## APPENDIX C – STAKEHOLDER FEEDBACK RECEIVED

**From:** [REDACTED]  
**Sent:** 22 July 2019 12:53  
**To:** [REDACTED]  
**Subject:** RE: Heathrow - Compton 09L/R Standard Instrument Departure - Airspace Change

### **Heathrow – Compton design principle engagement**

**Fig. 1** Existing easterly operations departure Compton SIDs

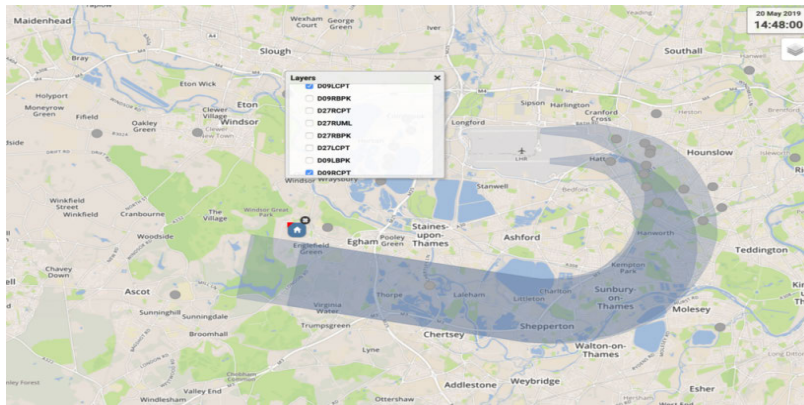
- The existing Compton SID (Standard Instrument Departure), see Fig. 1, has not been flown for 30 years<sup>1</sup>
- Up to June 2014 the flown Compton SID, see Fig. 3, did not impinge on Englefield Green, Egham, Virginia Water, etc. instead flying to the east of the M25 and south of the M3, flying over Addlestone in Runnymede Borough.

**Fig.3** The diagram above, obtained by an FOI request, shows the aircraft tracks on the easterly Compton SID prior to June 2014, (completely avoiding Englefield Green, Virginia Water, in fact the majority of Runnymede Borough).

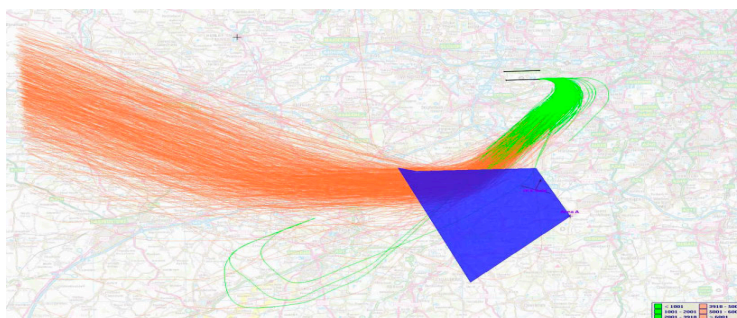
As established by an FOI (Freedom of Information) request, the aircraft tracks on the easterly Compton SID prior to June 2014, (which completely avoided Englefield Green, Virginia Water, in fact the majority of Runnymede Borough) where NATS (National Air Traffic Services), without public consultation, altered the flight path bringing it over Englefield Green, see Fig. 4.

**Fig. 4** The diagram above shows the post June 2014 tracks that now cross Englefield Green, Egham, Virginia Water, etc. Prior to June 2014 these areas were not affected by the easterly Compton SID, see Fig. 3.

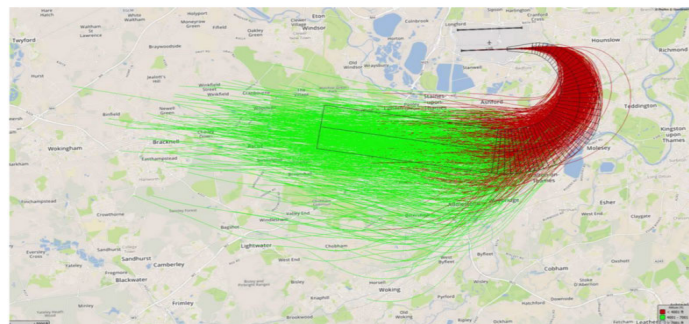
- In June 2014, **without public consultation**, the flown Compton SID was moved, see Fig. 4, to the west of the M25 and north of the M3, bringing flights over Englefield Green, Egham, Virginia Water and away from previously overflown Addlestone.

Without public consultation NATS altered the Compton SID flight path to directly fly over Englefield Green, Egham, Virginia Water, etc.

**Fig. 6** Easterly Compton ACP Proposal

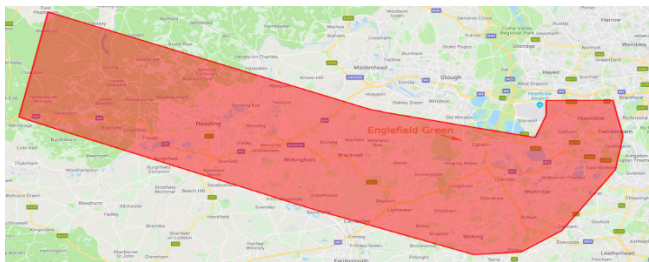
This area entirely covers Englefield Green and indeed the whole of Runnymede Borough. Currently aircraft are dispersed along a corridor width of 10km or so, see Fig 4. and Fig. 5, providing natural dispersion and non-concentrated flights. As proposed by Heathrow's ACP, if this corridor is replaced by a single concentrated PBN route 10's of meters wide, thus concentrating aircraft by a 1000 times, those under this concentrated PBN route area will be living in, what the CAA CEO termed, 'a Noise Sewer', effectively unfit for human habitation.

# Why PBN does not work over high population densities

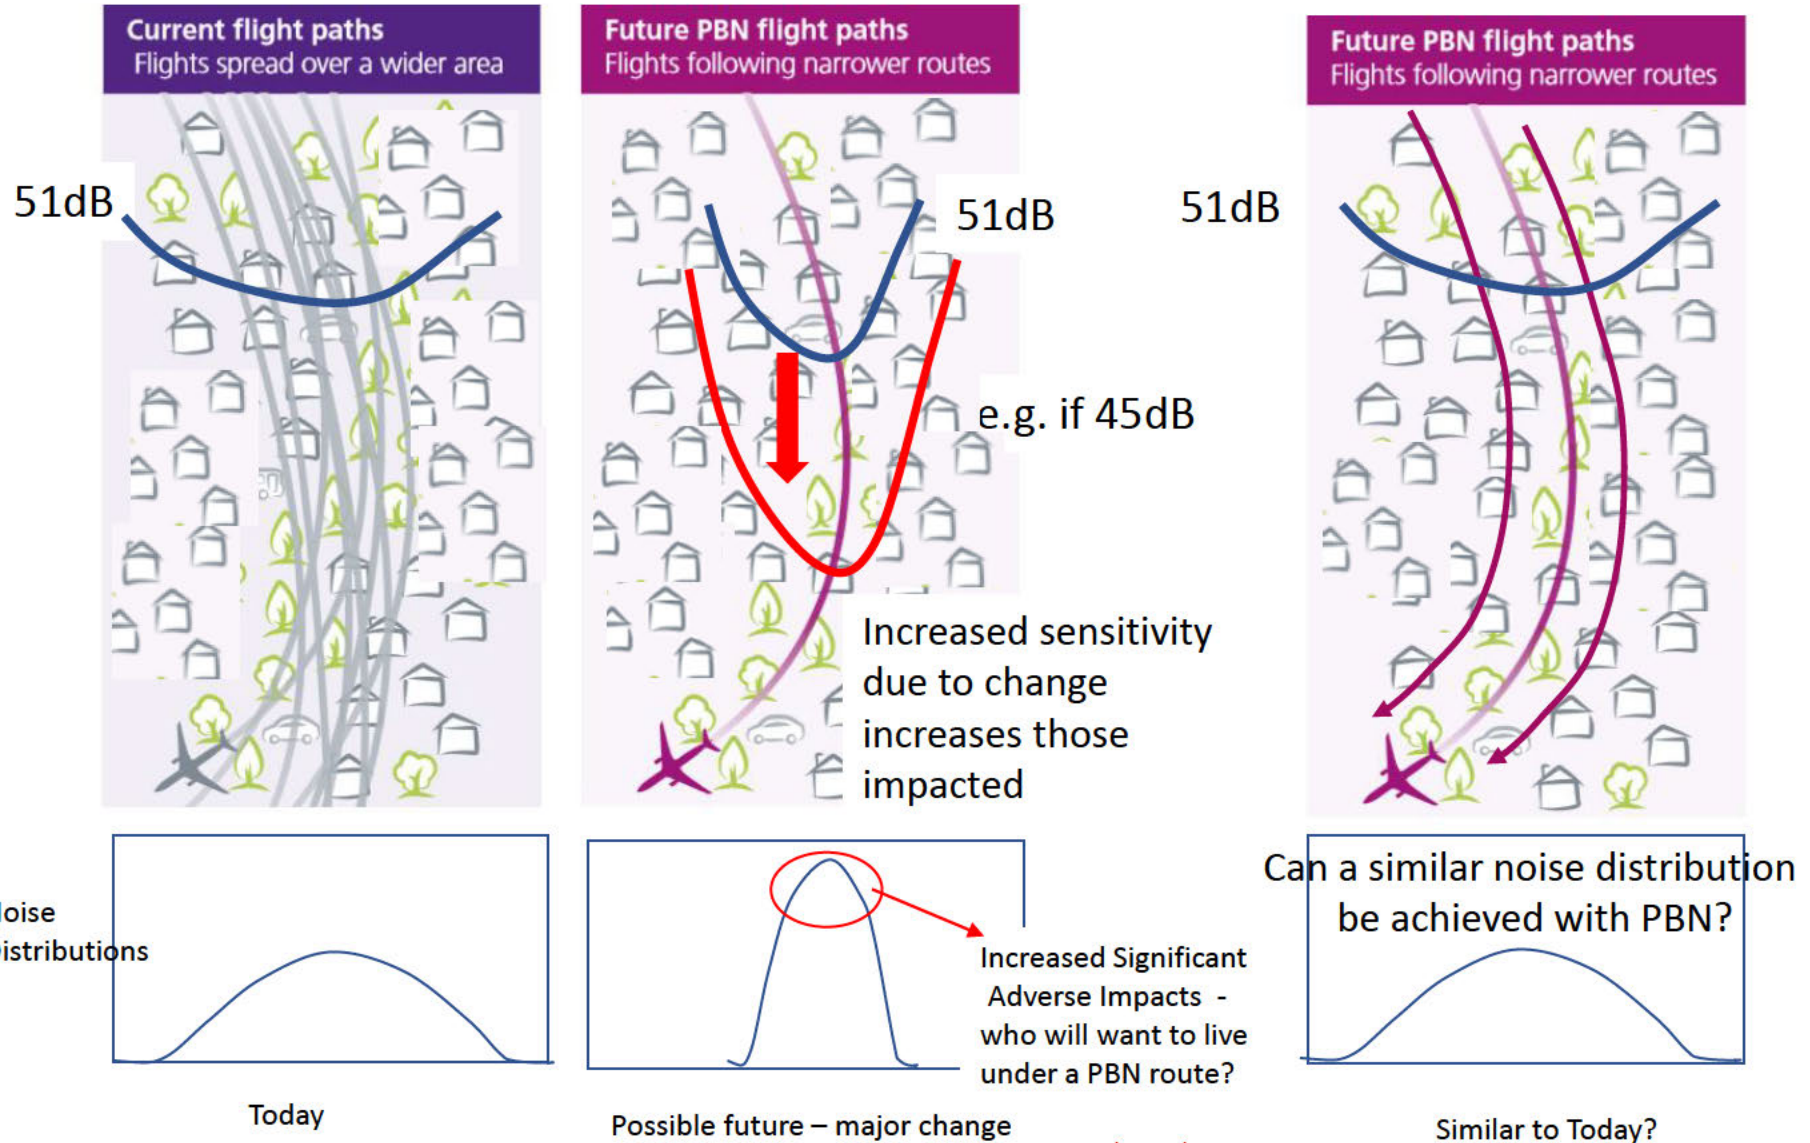
- Heathrow want to introduce PBN
- Concentrating flights has met with universal problems (1) – this must be avoided at all costs

- All evidence now points to making airspace changes increases annoyance by 6-9dB in LAeq terms or to have the same annoyance levels flights must be reduced by 400%-800% (2)
- According to Heathrow's CEO it wants to avoid increased annoyance and therefore to maintain similar numbers of flights it must aim to reproduce the existing noise footprint
